REMARKS

VERSION OF AMENDED ITEMS WITH MARKINGS TO SHOW CHANGES MADE

August 29, 2001

FIG. 1A

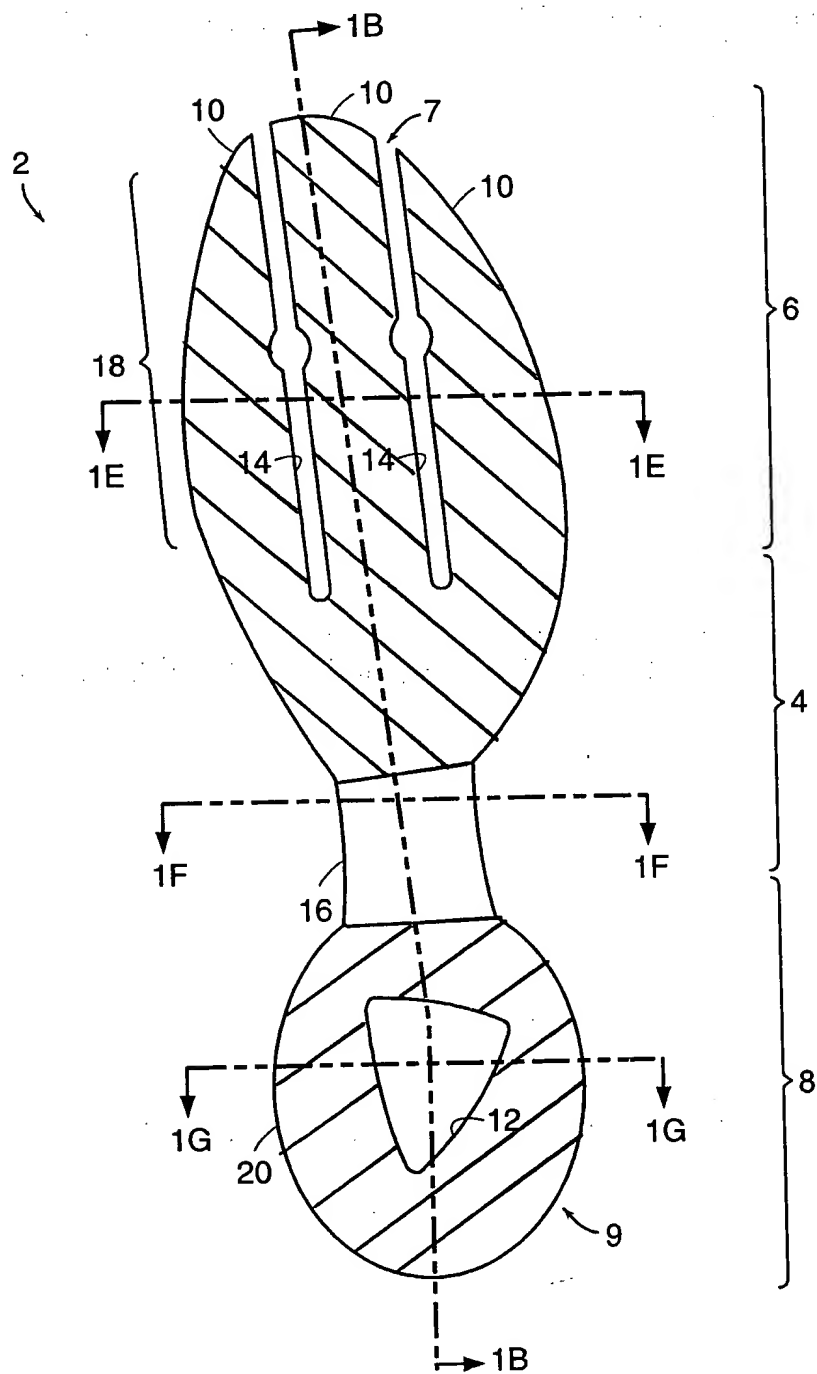
The cross-sections depicted in Figures 1B-1G, 2B-2G, and 3B-3G show, by way of example, differing thicknesses as claimed in claims 12-16. Applicant has added shading that is consistent with MPEP § 608.02(m) to Figures 1A, 2A, 3A, and 4 to show the differing materials as claimed in claims 17 and 18. Applicant has amended the specification to describe the shading. Further, Applicant has modified Figures 3B-3G to include an intermediate layer 203 as claimed in claims 32-34 as filed (amended herein to appear as claims 36-38). Applicant has amended the specification to include a description of the new reference designator (203) associated with the intermediate layer. Applicant has also amended the specification to correct a typographical error in referencing figures 3B-3D.

Reference designator 107 appears in Figures 2A through 2D, and reference designator 207 appears in Figure 3A. In comparison, Figure 1A shows another embodiment of the invention where reference designator 7 refers to a toe portion. The specification describes the toe portion 7 at, for example, p. 6, l. 8. Consequently, it is clear that Applicant adopted a common reference designator numbering scheme (i.e., ending in “7,” as in “107” and “207”) to identify the toe region in the various embodiments of the invention. Accordingly, Applicant has amended the specification to associate reference designators 107 and 207 with the toe portion shown in Figures 2A through 2D, and Figure 3A, respectively.

The chassis 2, 102, 202, or chassis/skin construct 201 can also be designed to provide more stiffness to certain areas of the article of footwear and less stiffness to other areas by varying the types of material used to manufacture the chassis 2, 102, 202 or chassis/skin construct 201. Thus, stiffer materials can be placed in areas requiring greater support and power transfer and less stiff materials can be placed in areas requiring greater flexibility, such as a forefoot flex region. The different shading in

Figures 1A, 2A, and 3A defines, by way of example, areas where the various types of materials may be used.

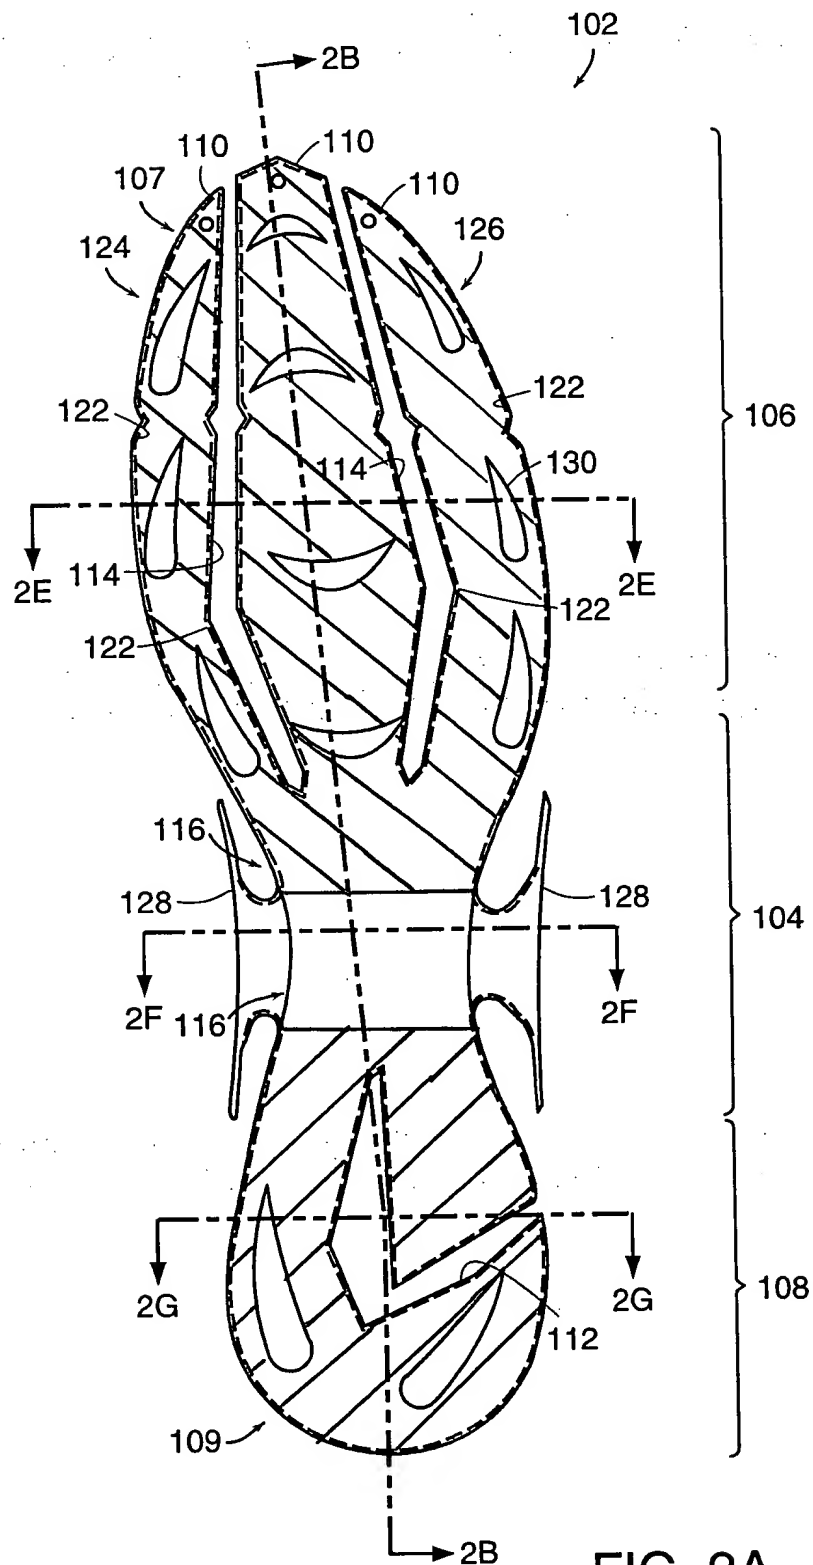
The Office Action further states that in claim 5 the phrase “a fold line” is vague and indefinite. Fold lines 122, 222 appear in Figures 2A and 3A. As detailed in the specification at p. 8, ll. 11-12 and p. 10, ll. 23-24, the fold lines 122, 222 are essentially indentations that facilitate bending in certain areas of the chassis 102 and chassis/skin 201. As discussed with, and endorsed by, the Examiner, Applicant has amended claim 5 to replace the term “fold line” with “indentation.” Applicant respectfully submits that claim 5, as amended herein, is sufficiently clear and definite and is therefore allowable.

Fig. 2A depicts a bottom plan view of another embodiment of the chassis 102 of the present invention. In this embodiment, a forefoot portion 106 and a rearfoot portion 108 extend into a toe portion 107 and a heel portion 109, respectively. In this embodiment of the chassis 102, the finger-shaped elements 110 in the forefoot portion 106 have fold lines 122 as well as spaces 114 therebetween. The fold lines 122 and spaces 114 of the finger-shaped elements allow for greater flexibility in the forefoot region 106. In the process of walking or running, the forefoot region 106 of a wearer bends as he shifts his weight from his heel to his forefoot and then pushes off with the forefoot. These finger-shaped elements 110 and spaces therebetween 114 allow for greater and easier bending in this region.

FIG. 2C

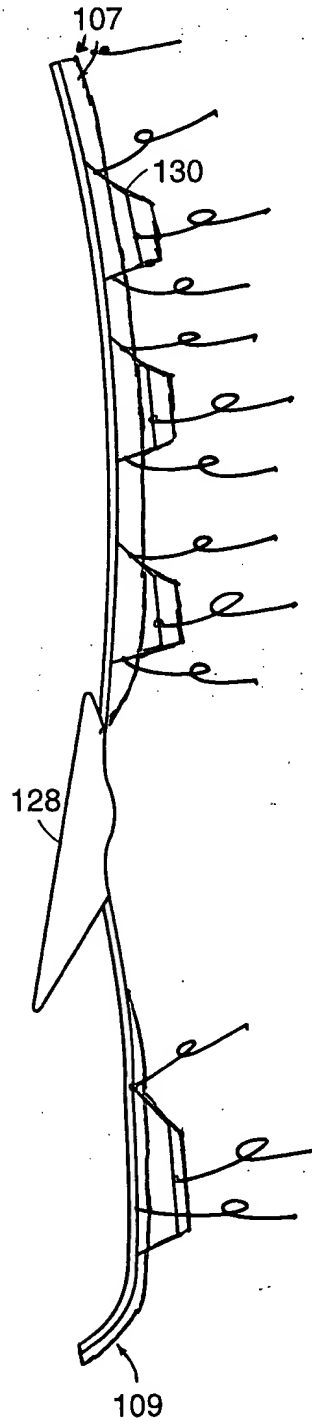
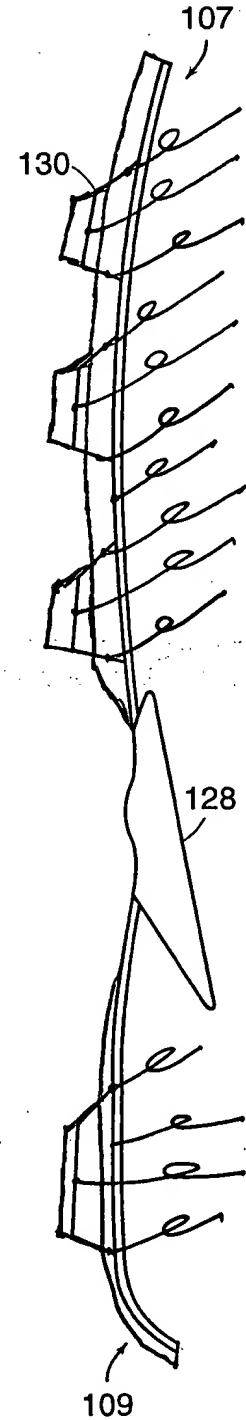
Reference designator 228 appears in Figures 3A, 3C, and 3D. In comparison, Figures 2A, 2C, and 2D show another embodiment of the invention where reference designator 128 refers to side elements. The specification describes the side elements 128 at, for example, p. 8, l. 4. Similar to the above, it is clear that Applicant adopted a common reference designator numbering scheme (i.e., ending in “28,” as in “228”) to identify the side elements in the various embodiments of the invention. Accordingly, Applicant has amended the specification to associate reference designator 228 with the side elements shown in Figures 3A, 3C, and 3D.

FIG. 3A

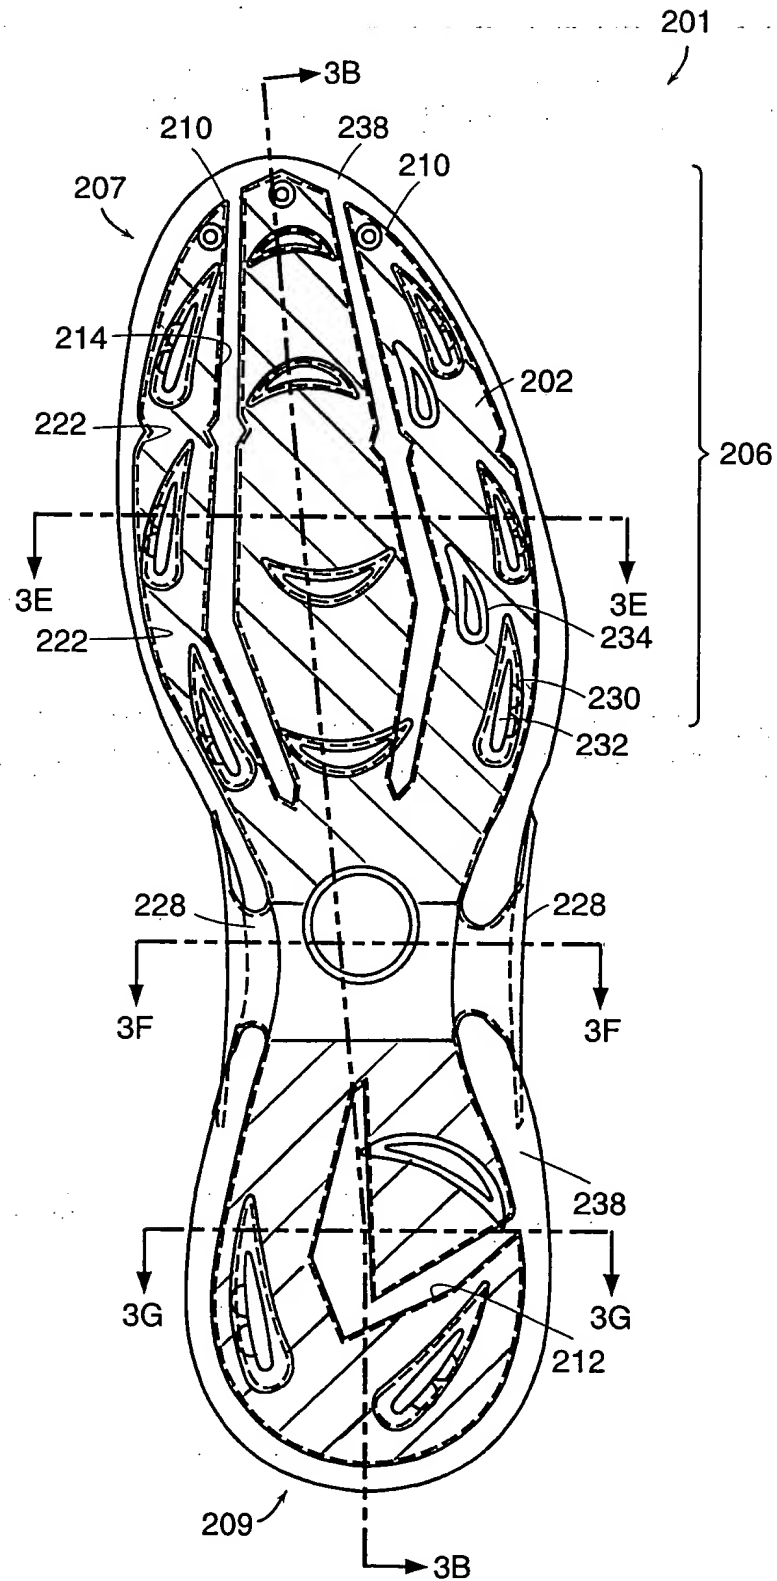
With respect to Figure 3A, Applicant has added the inadvertently omitted reference designator 206 identifying the forefoot region. No new matter has been added, since "forefoot region 206" is described in the specification as filed at, for example, p. 10, l. 24.

Fig. 3A shows a plan view of the bottom side of the chassis/skin 201. The finger-shaped elements 210 in the forefoot region 206 have fold

lines 222 to facilitate flexing at these regions. The forefoot region 206 includes a toe portion 207. The opening 212 in the heel portion 209 is in the shape of a chevron. Figs. 3B-3C-3D show a cross-sectional view along section 3B-3B, a medial side view, and a lateral side view, respectively, of the chassis/skin construct 201. Figs. 3E-3G show cross-sectional views along sections 3E-3E, 3F-3F, and 3G-3G of the chassis/skin construct 201. Figs. 3H-3I show end views of a toe view and a heel view, respectively.
